Application Note AN-1101

IRS210(8,84) and IR210(8,84) Comparison

Figure 7A. Turn-off Fall Time vs. Temperature

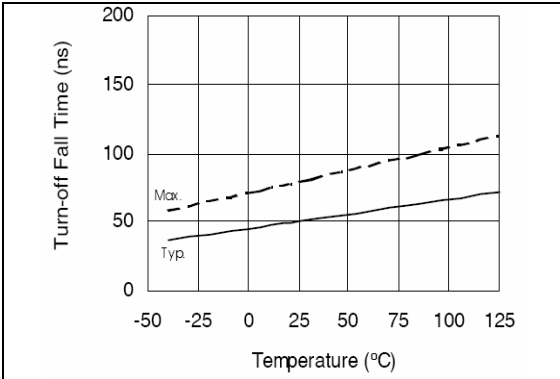
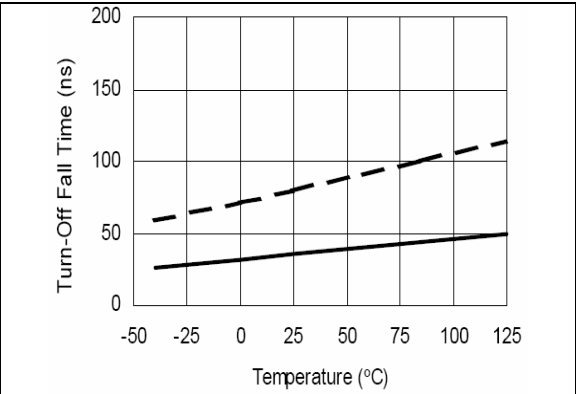
The IRS210(8,84) have faster rise and fall times when compared to the IR210(8,84).

Figure 9A. Logic "1" Input Voltage vs. Temperature

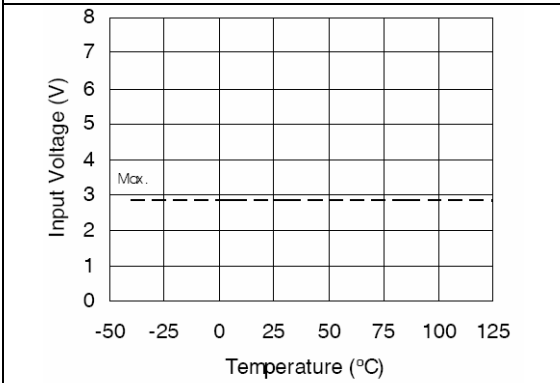
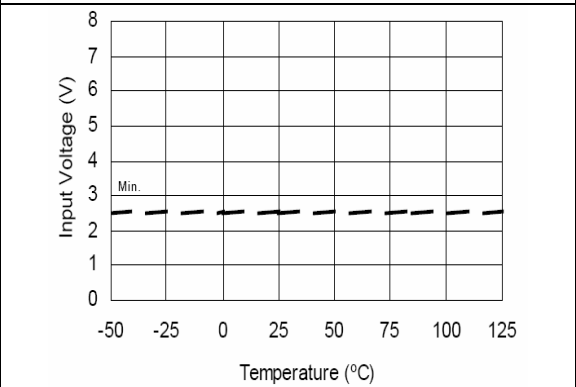
- V_{IH} is reduced to 2.5 V for better 3.3 V logic compatibility.
- The V_{OH} and V_{OL} are tested using a new standardized test condition of $I_O = 2$ mA. The output driver's on resistance is lower for IRS210(8,84), which improves immunity against the Miller effect.
- The typical values for I_{O+} and I_{O-} are increased, which allows faster switching.
